Application for Planning Permission for Proposed Temporary Green Fuel Station for Electric Private Vehicles with Ancillary Facilities for a Period of 3 Years at Lots 1343RP(Part), 1356RP in D.D. 78 and Adjoining Government Land, Lin Chuk Road, Ta Kwu Ling North, N.T.

(Application No. A/NE-TKLN/124)

Table 1: Responses to Comments from Government Departments on Planning Application No. A/NE-TKLN/124 (1 June, 2026)

Drainage Proposal in support of
Planning Application No. A/NE-TKLN/124
for Temporary Green Fuel Station for Electric Private Vehicles with
Ancillary Facilities for a Period of 3 Years
at Lots 1343 RP (Part), 1356 RP in D.D. 78
and Adjoining Government Land, Lin Chuk Road, Ta Kwu Ling North,
New Territories

FIGURE D3

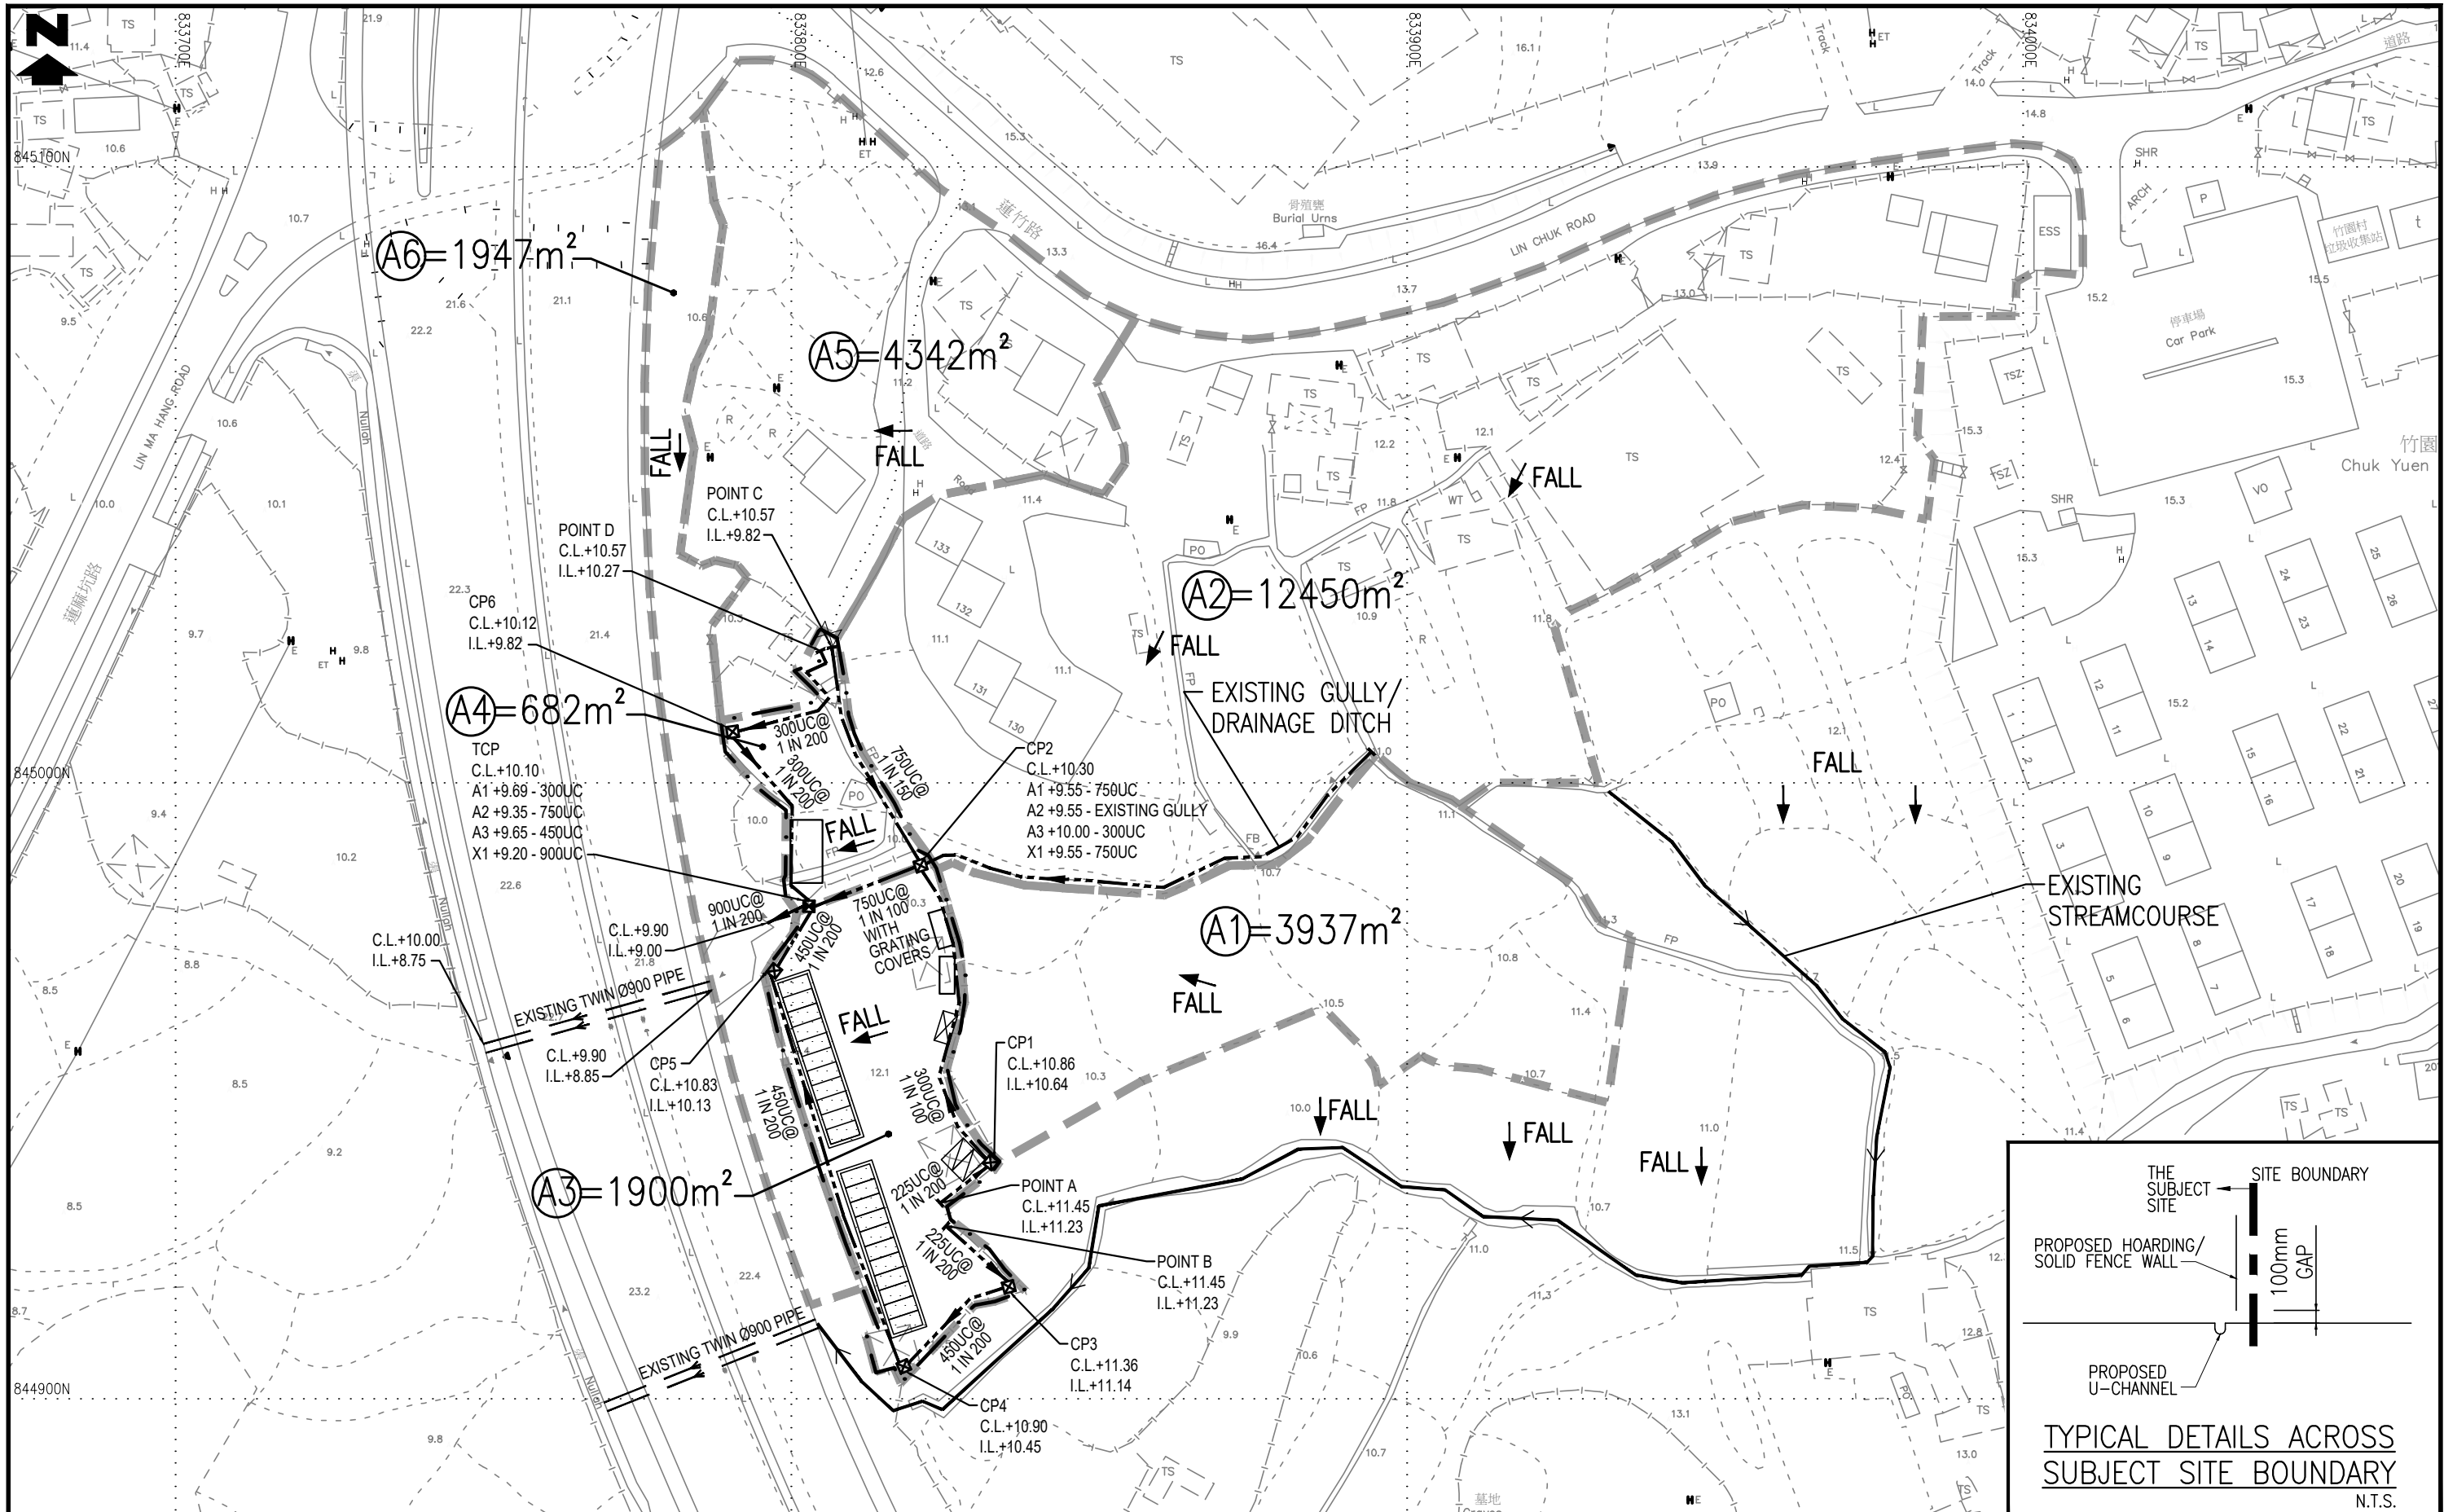
2.	Drainage Services Department	
(1)	It appears that a pond and a drainage channel situated within the site would be filled/adversely affected by the proposed use. Unless the applicant can submit a satisfactory drainage proposal to mitigate the possible drainage impacts arising from the proposed use to my satisfaction, I do not support the application.	The Applicant's consultant has prepared a Drainage Proposal (see Annex 1) for consideration by DSD.

- 3.1 At present, the subject site is a piece of flat grassland with ground levels ranging between +9.9mPD and +10.83mPD. It generally slopes from its eastern to its western boundary (refer to **Photo Nos. 1 and 2**). There is an existing gully running across the northern portion of the subject site from the eastern to the western boundary. The gully receives flow from the drainage ditch of the adjacent farmland to its east (refer to **Photo Nos. 3 and 4**), and discharges its flow into an existing stormwater inlet under the elevated Heung Yuen Wai Highway from which the flow will pass through twin 900mm diameter drains and go to the west (refer to **Photo Nos. 5 and 6**).

3.3 Current conditions of the subject site and its surrounding areas are shown in the following photos (photo taking locations are shown in **Figure D3**):
